Proposed ESD for Detrex Source Remedy

Fields Brook Superfund Site

Meeting with EPA

November 16, 2011

Conceptual Design – Additional DNAPL Recovery Wells Schematic

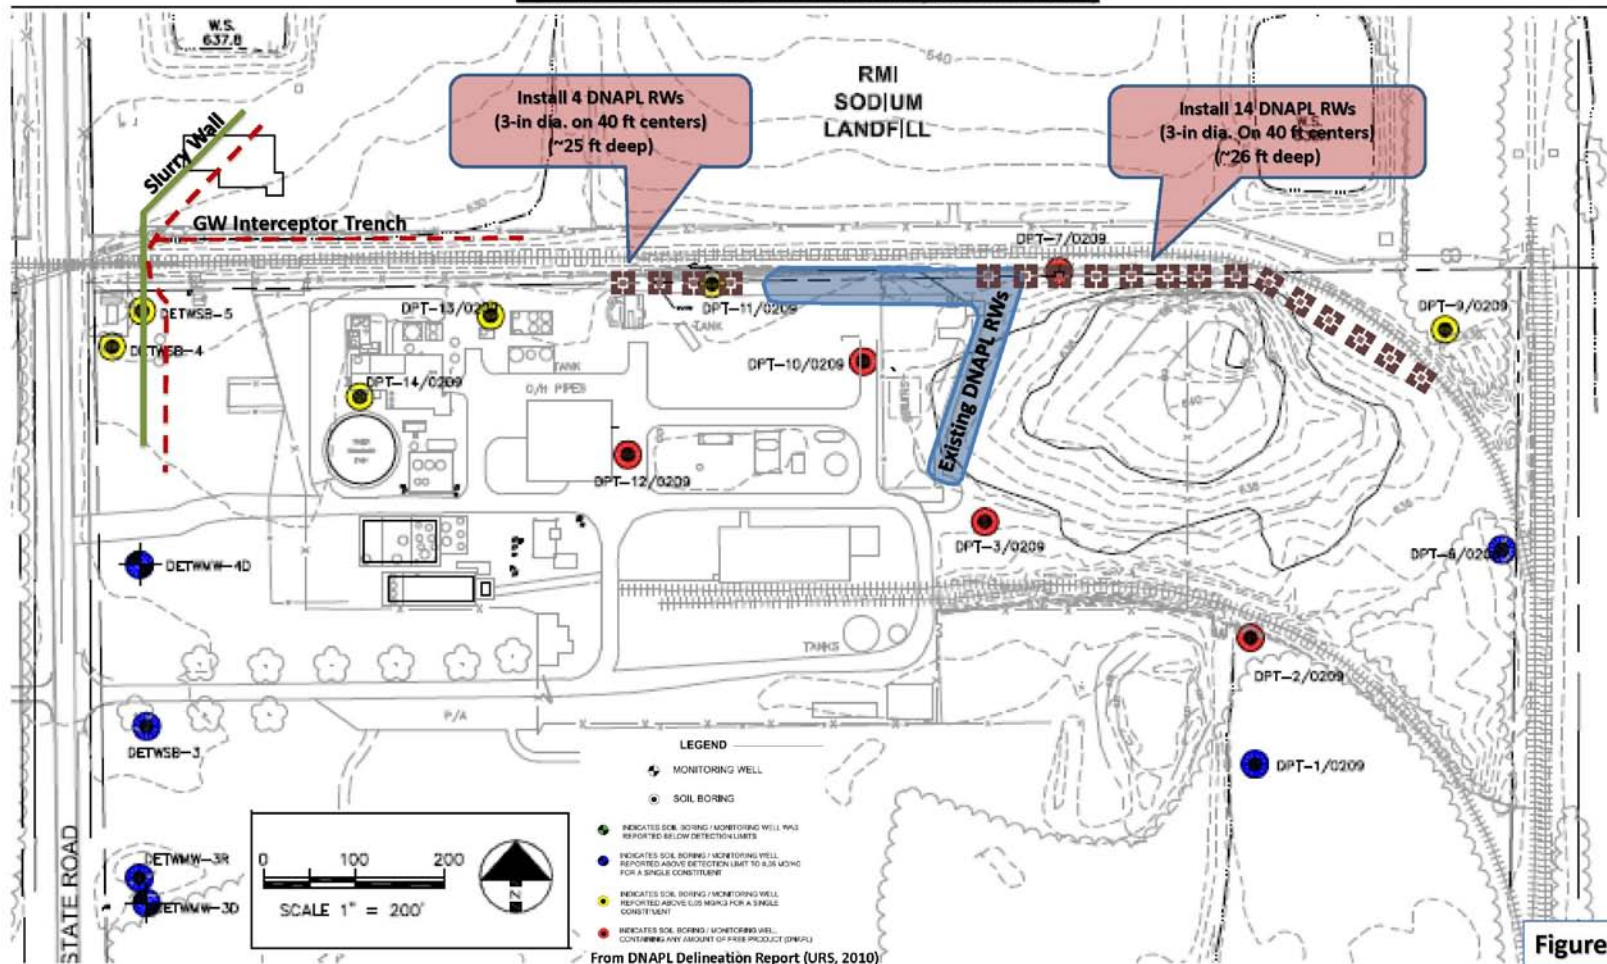
Detrex-Proposed DNAPL Recovery Wells

- Detrex proposed remedy is a passive containment system – inconsistent with ROD
 - › Does not meet “treatment” requirements for Principal Threat Waste
 - › Passive, manually-operated, gravity-fed DNAPL recovery system *versus* ROD-approved vacuum-enhanced extraction system
 - › Wells located along edges of lagoons – allows for only containment rather than mass removal
 - › Only addresses free phase DNAPL vs. ROD requirement that all phases (vapor, dissolved, and free) be addressed

Conceptual Design –DNAPL Slurry Wall & GW Collection Trench Schematic

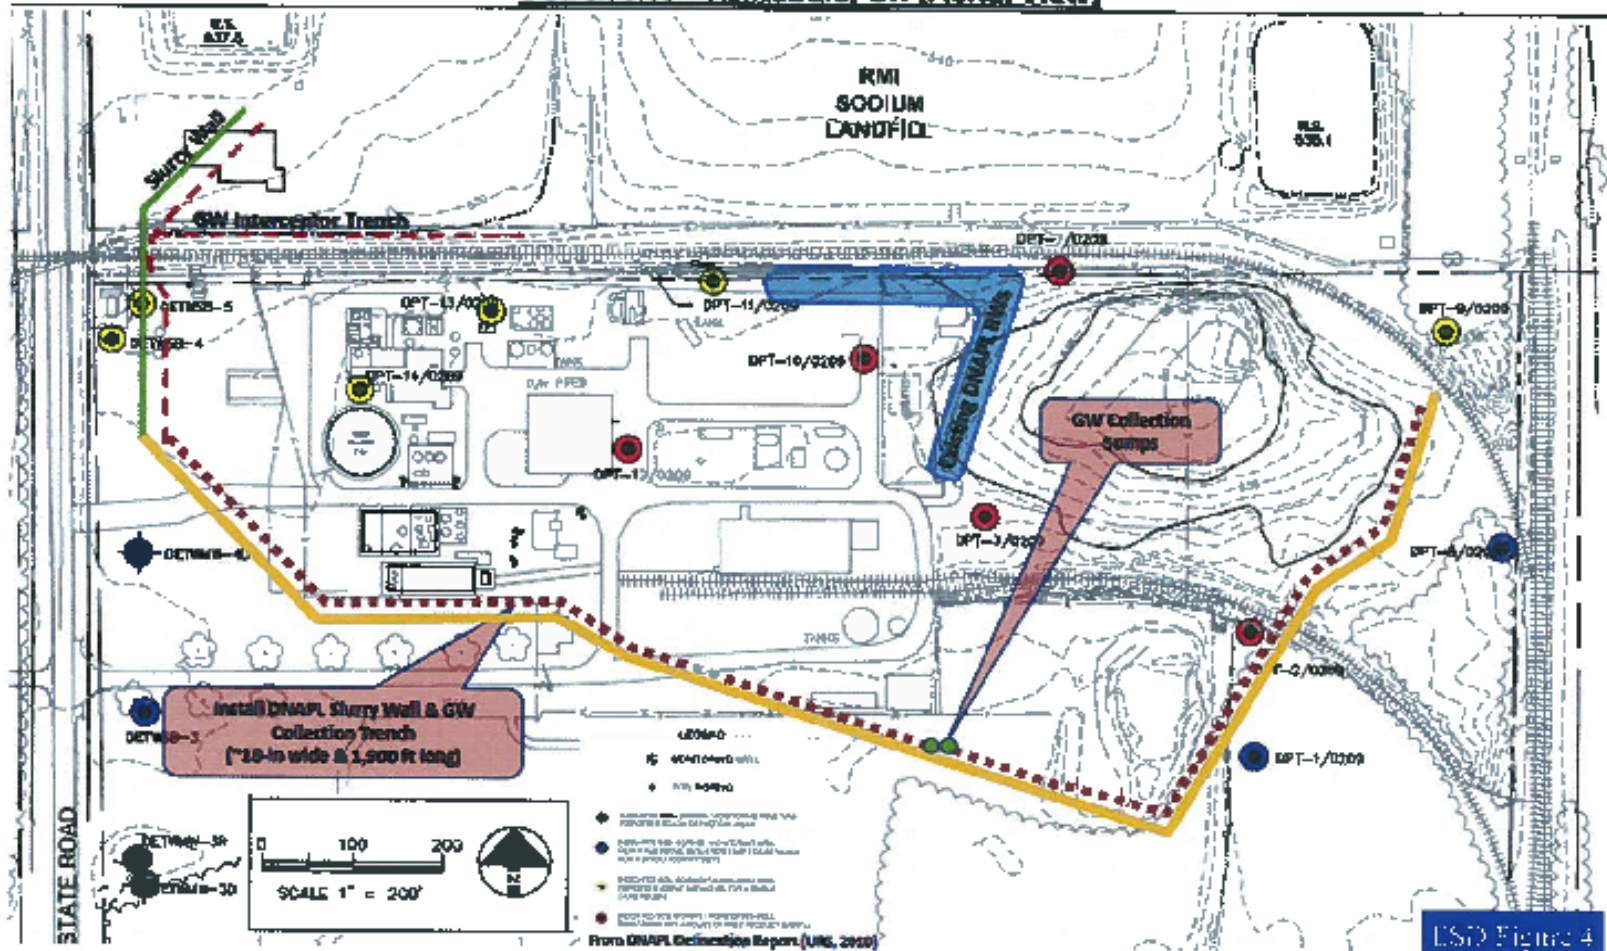
Detrex-Proposed Slurry Wall

Conceptual Design – DNAPL Recovery Soils Management Area Location

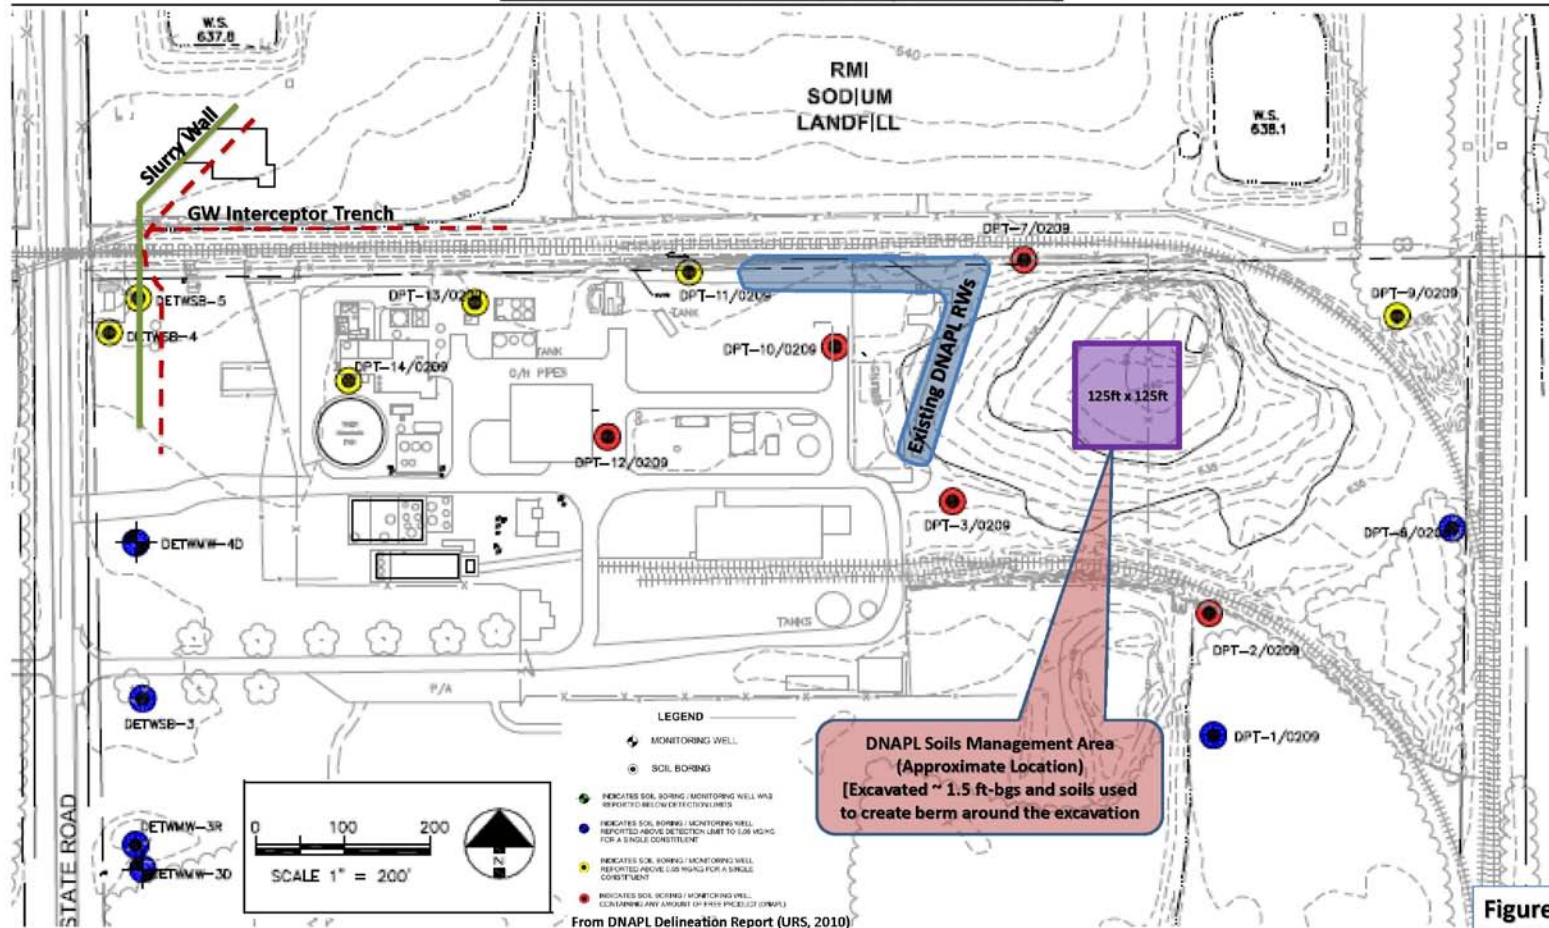
Detrex-Proposed DNAPL Soil Management Area
